UNIVERSITY OF KENTUCKY Purchasing Division

CCK-2602-22

ADDENDUM # 1

ADDENDUM #1 – BID PACKAGE #2

M3.0

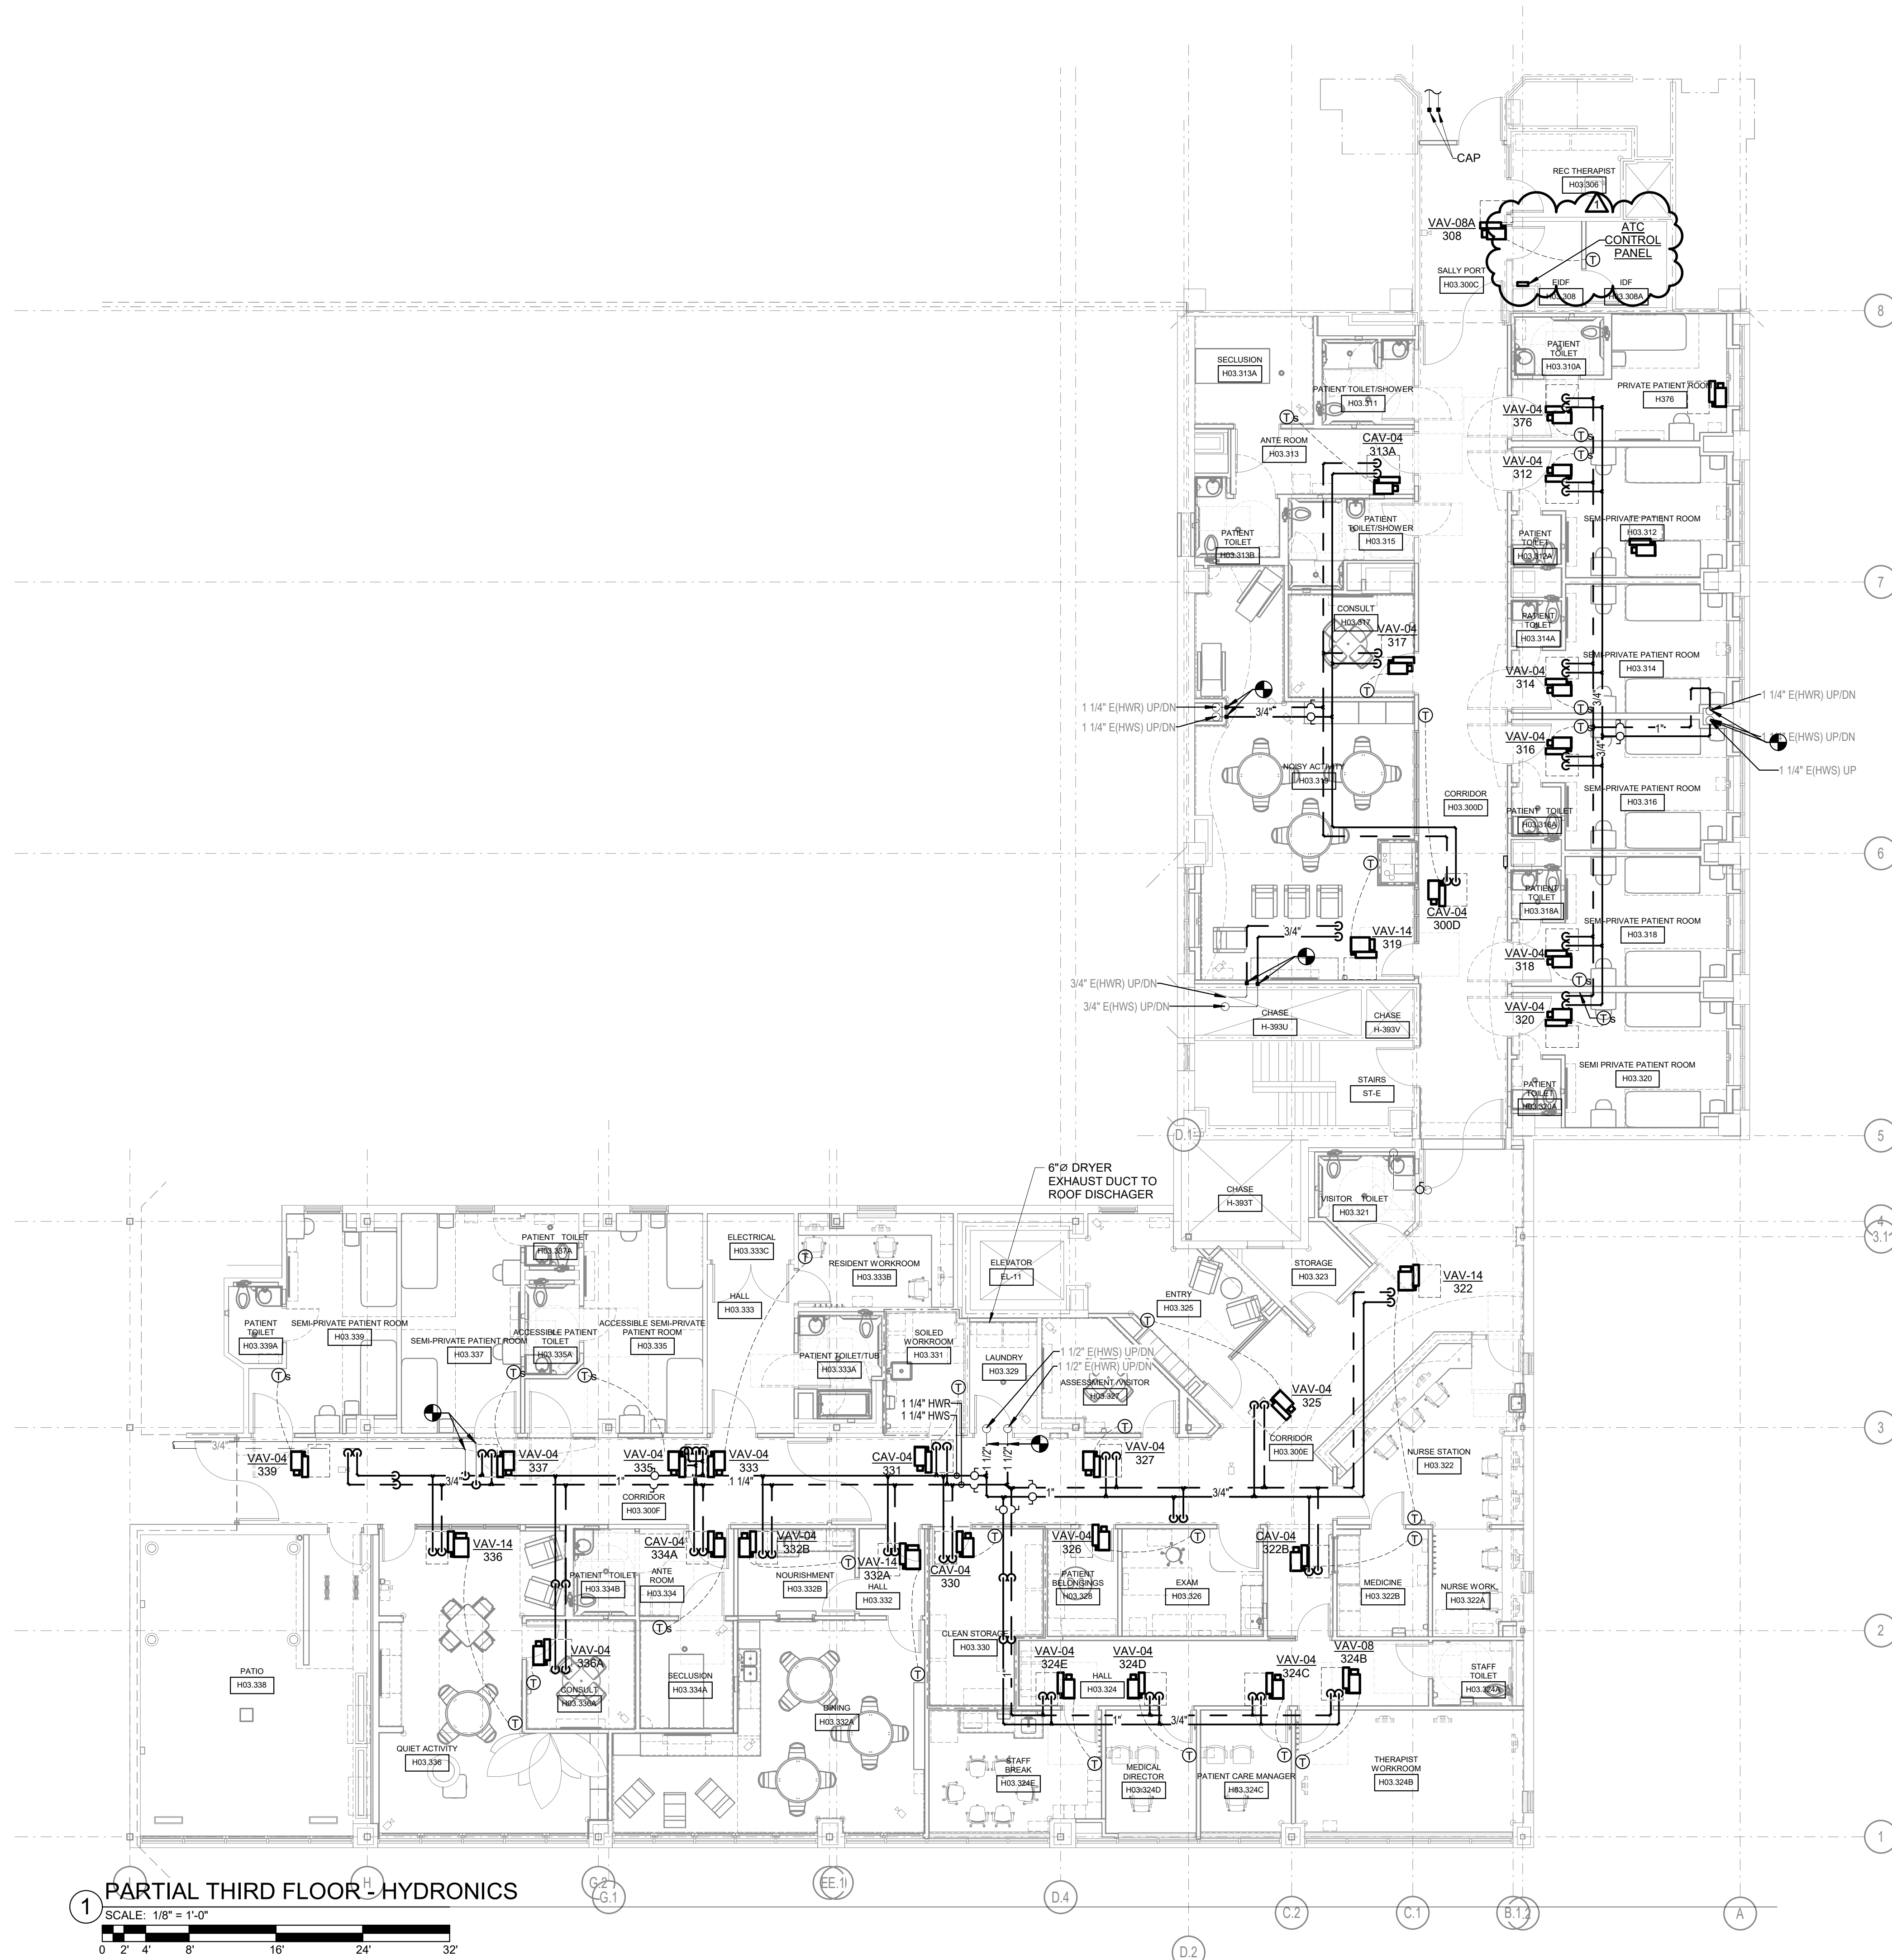
3.23 Reference: Sheet M3.0

E4.0

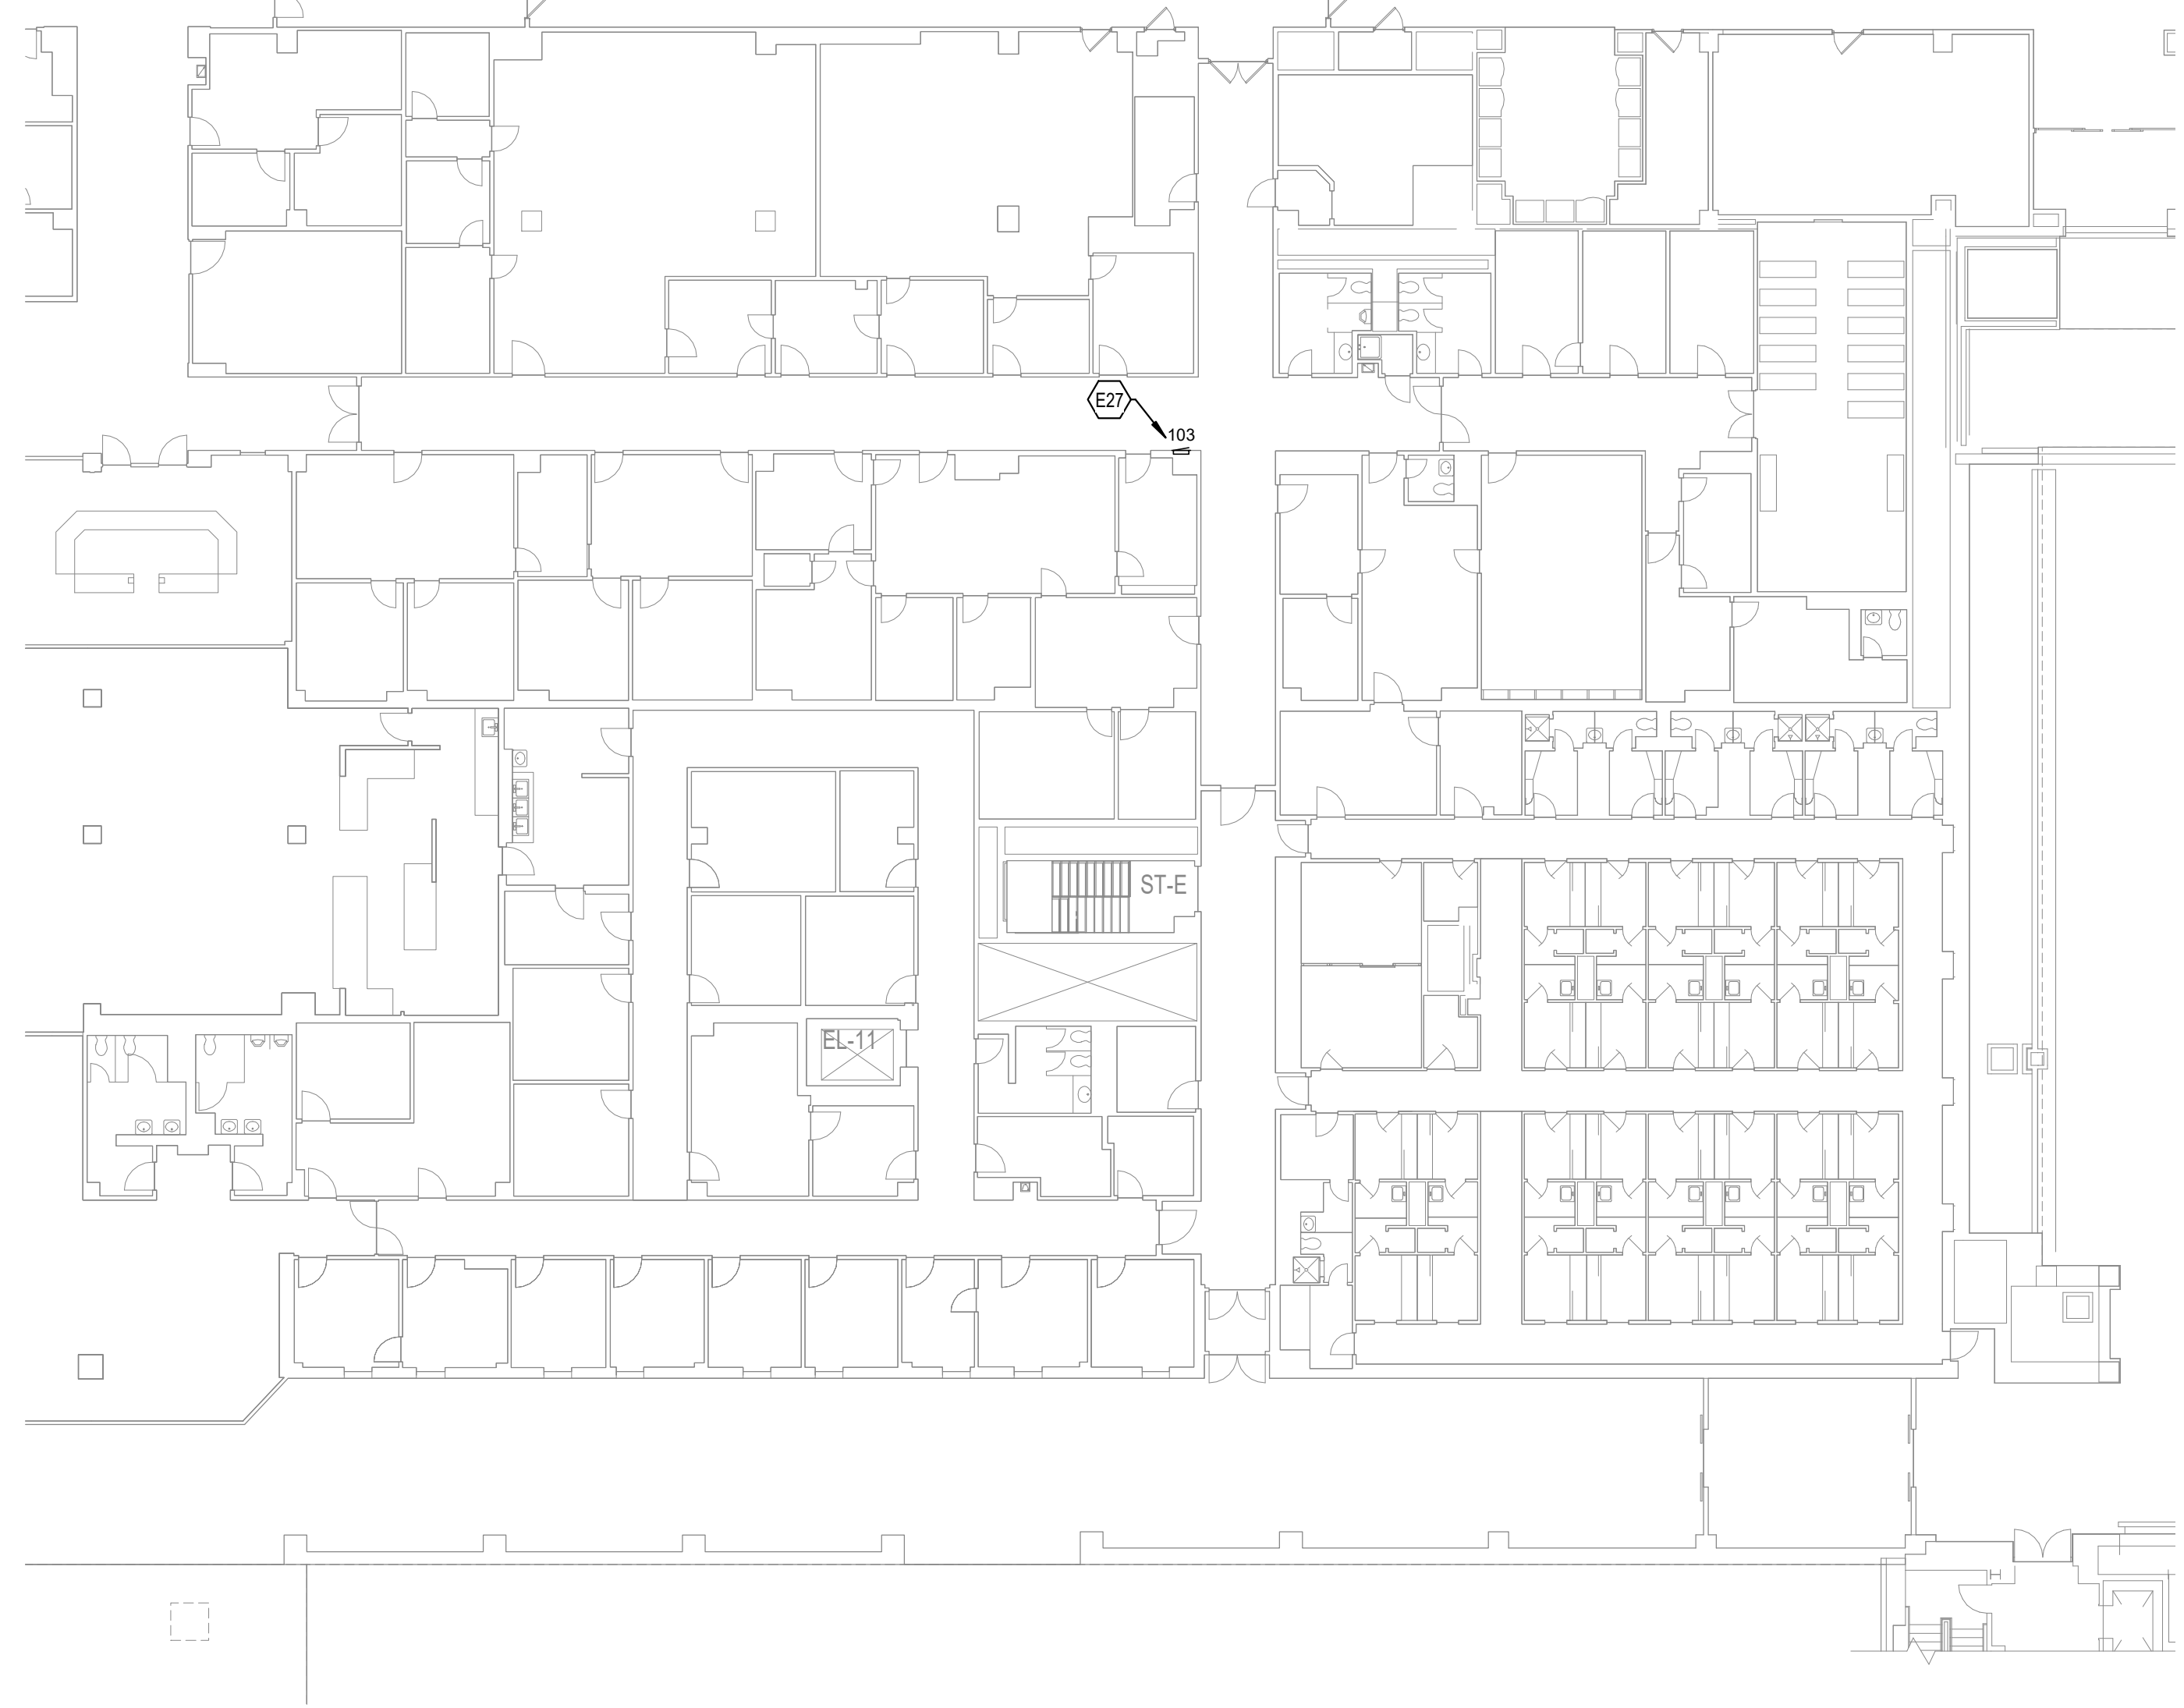
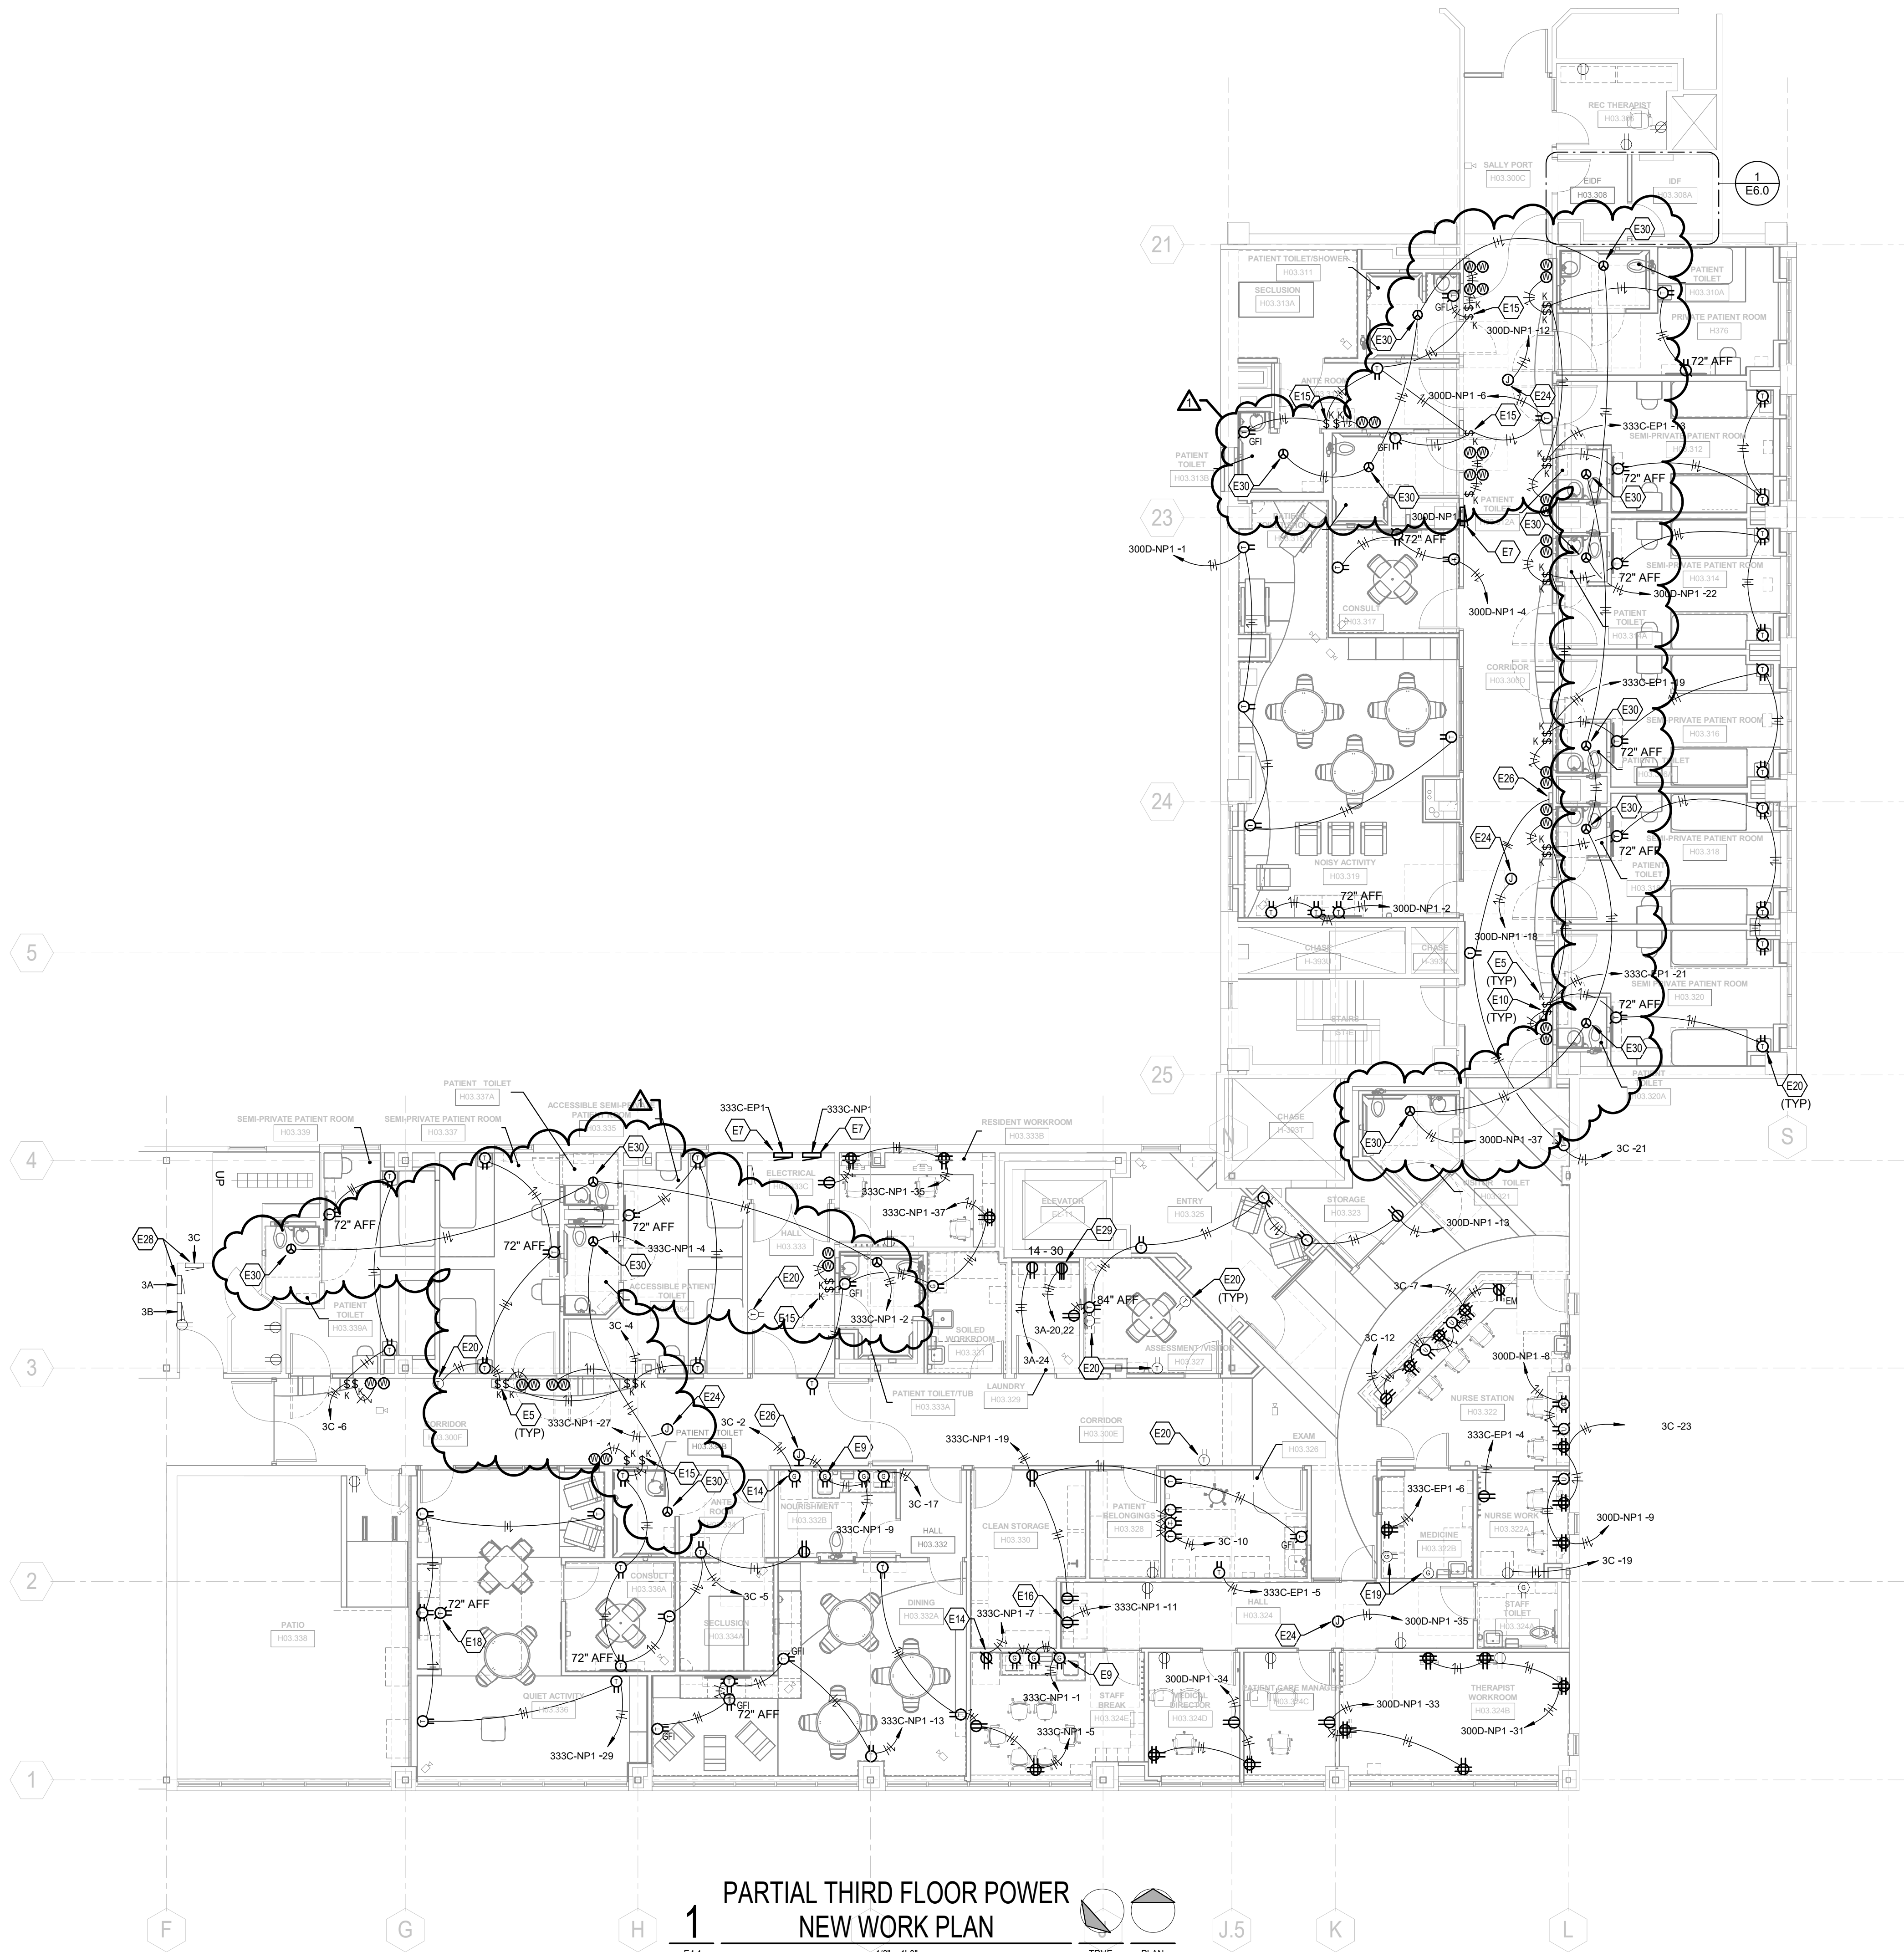
3.15 Reference: Sheet-E4.0
